MEMORANDUM

SUBJECT: Final Report – Revised Application for Zoning Commission Case No.06-10 Consolidated and Preliminary Planned Unit Development and Map Amendment for proposed “Art Place and Shops at Fort Totten”

DATE: June 22, 2009¹

Figure 3: Preliminary Viewshed Analysis

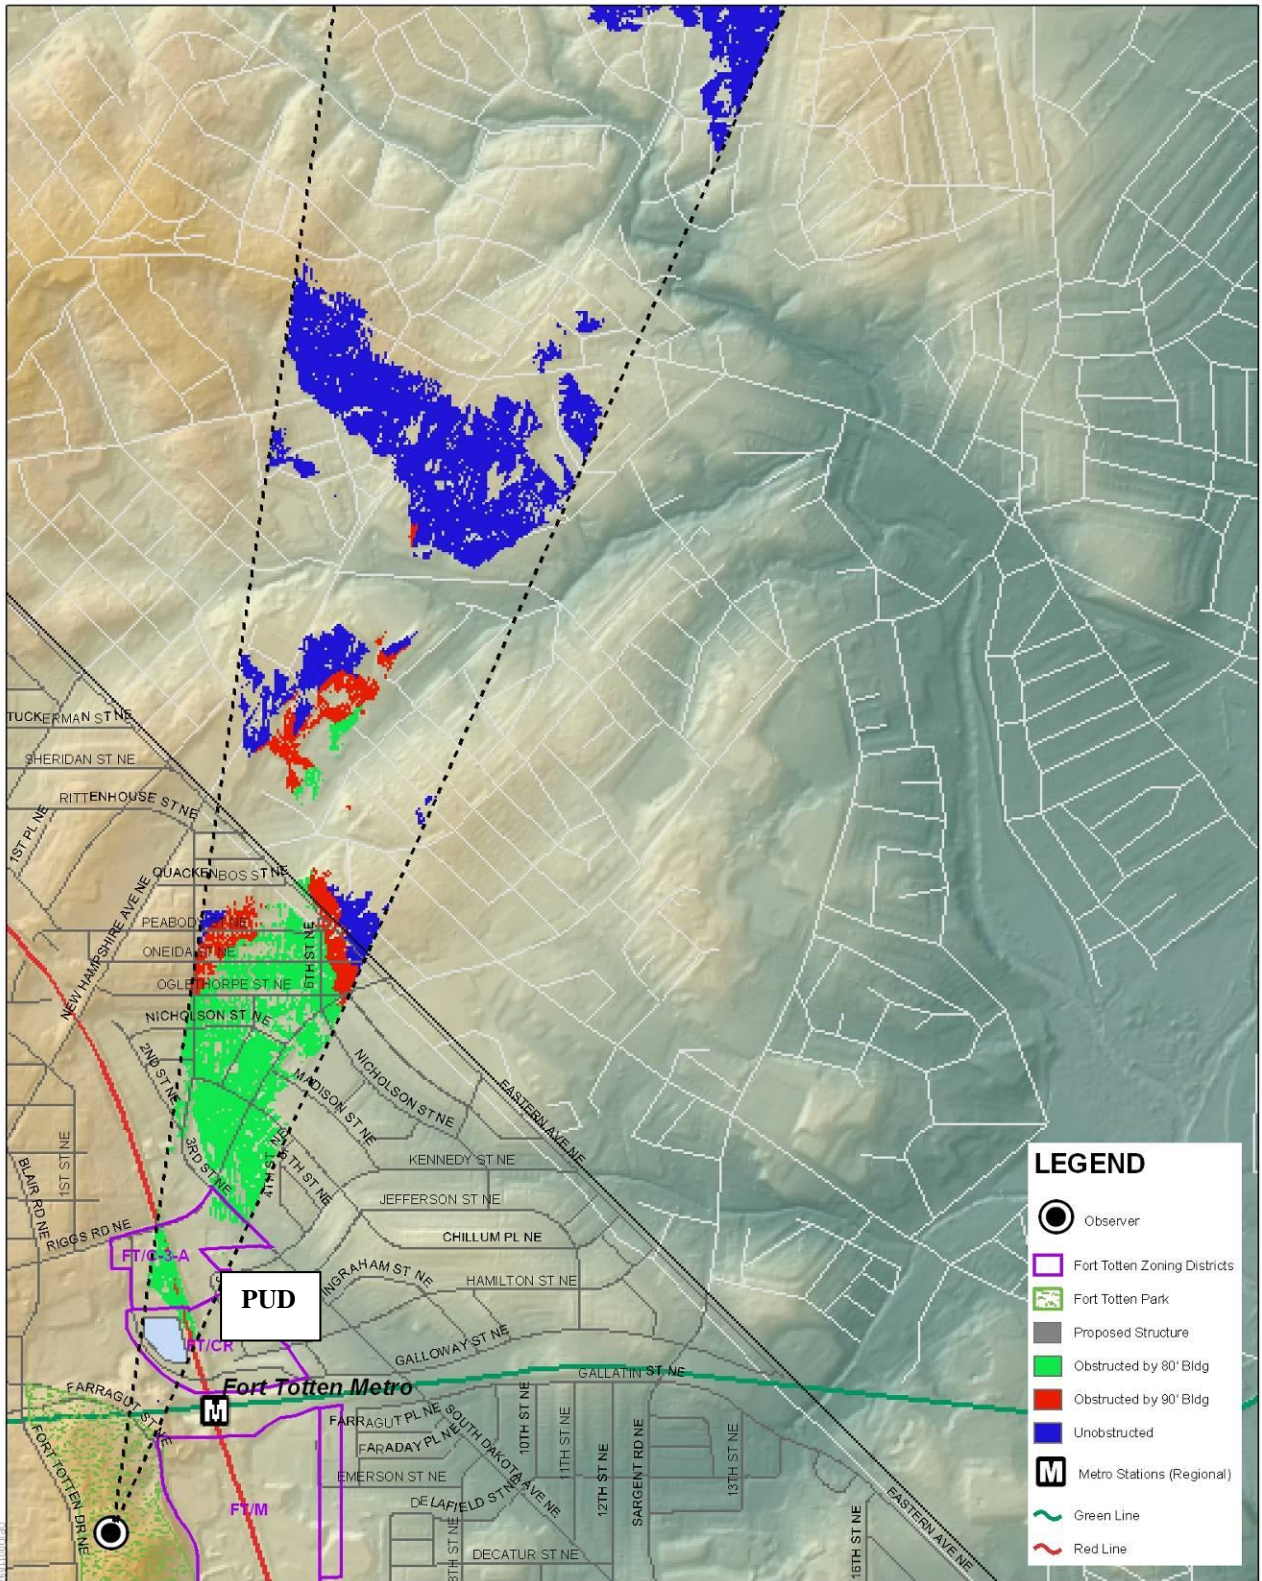
Part of Building C in the Preliminary PUD would be within the current Fort Totten (FT) overlay. It is proposed to be 90 feet high. The FT Overlay is designed to protect views from the historic Civil War fort by requiring review of roof structures, step-backs, parapets, etc. that are above 65’ and within the overlay’s boundaries. Although the applicant has requested a PUD-related rezoning that would leave none of the site within the FT overlay, OP has analyzed the possible impact of the proposed building’s height. The analysis presented in Figure 3, indicates that there would be little, if any, impact from the height of tallest buildings. This analysis did not evaluate the impact of the design of the buildings above the 65’ level, since such detailed designs are not usually presented until the second stage of a preliminary PUD.

The applicant has presented a comparable viewshed analysis on Sheet 37 of its June 12, 2009 filing.
